Work Order ID 93824

Item Name: Crosstube Low Standard Aft

DRAWING NO. D412-664-249	TITLE CROSSTUBE ASS'Y (412 LOW AFT)	REV. B	DART AEROSPACE LTD ENGINEERING ORDER		D.E.O. NO. D412-664-249-B-1	SHEET NO. SHEET 1 OF 2	SCALE NTS
DRAWN 92	CHECKED SC	MFG. APPR. E	APPROVED MD		DE APPR. H		
DATE 11.05.25	DATE 11.05.31	DATE 11.05.31	DATE 11/05/31		DATE 11.05.31

D412-664-609
BENT TUBE

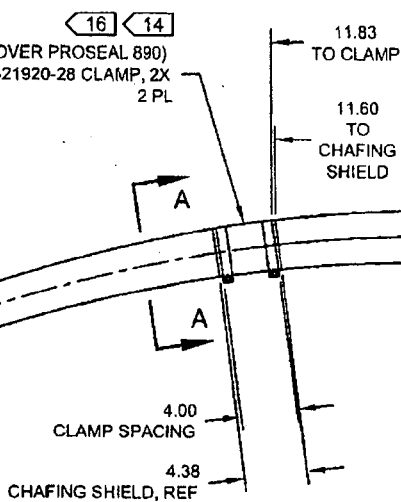
D3189-1 CHAFING SHIELD (1, INSTALLED OVER PROSEAL 890)
MS21920-28 CLAMP, 2X
2 PL
